Subject: Broken Swing Check Valve Arm

No. 9102-77-002

Swing Check Valves

... Inspection of internal components recommended ...

SWING ARM

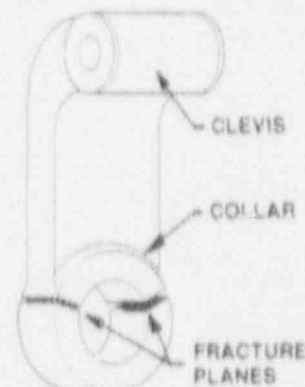
The fracture planes of the failed arm were in the collar region where arm attaches to the disc (see Figure). Corrosion products were found on the fracture faces. Failure analyses, performed by third parties under utility funding, included metallurgical examinations of five similar arms removed from valves in service that had not failed.

Examination showed a poor material condition in the failed arm consisting of casting defects, inadequate heat treatment and minor chemistry deviations. The significant casting defects were the presence of microcracks and shrinkage cavities formed during solidification of the casting and its subsequent cooling. These microcracks were not detectable using normal LP, MP and RT techniques. No microcracks were present in the other arms inspected.

Inadequate heat treatment in the failed arm and one other arm was evidenced by material hardness greater than Rc 35. Materials in this hardness range are more susceptible to hydrogen assisted cracking. The material microstructure showed the existence of well defined dendrites which also indicates the arm did not receive either a homogenization treatment or a double solution anneal.

A single occurrence of a swing arm failure has been experienced in a 4-inch 150 lb valve installed in a service water system. The failure occurred during hot functional testing and consisted of radial fractures, in two places, of the collar holding the disc/stud assembly to the valve arm.

Although this failure is considered to be an isolated occurrence, BW/IP International, Inc., considers it prudent to inspect all swing arm check valves at the next opportunity. Valves installed in systems with a high chloride content should receive special attention.

- Perform visual inspection of valve internal components.
- Perform PT/MT examinations if indicated by visual inspection.
- Replace any defective components.
